Re: 2058 NW O'Brien Rd  
Lot 144, Estates of Woodside Ridge  
Lee's Summit, MO  
Permit # PRRES20222996

Apex Engineers Inc. observed the house under construction at the above-referenced address. Our firm has been retained to address comments from the city rough-in inspection. For the purposes of this report, the house will be referred to as facing south.

Figure 1.0- Built-Up Stud Column

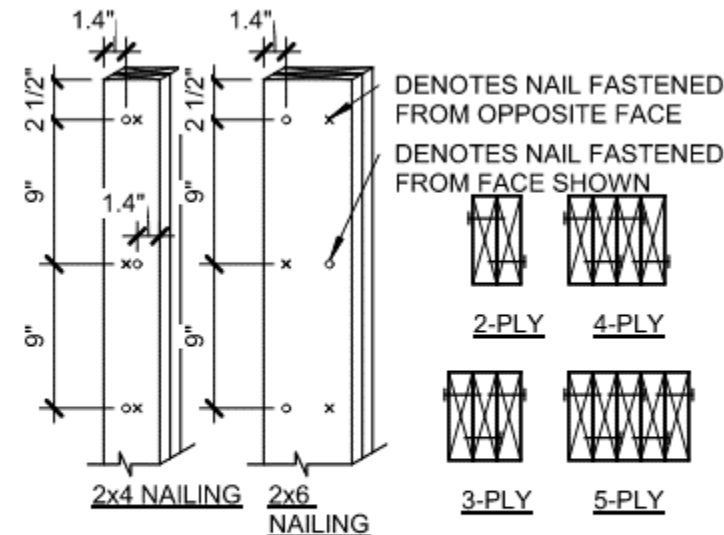
1. *Overnotched stud at garage dining room beam post*

- After computations, our firm has determined that a minimum of (8) 2x4 DFL studs are required to support the service loads of the structure. The studs shall be fastened per the detail below.
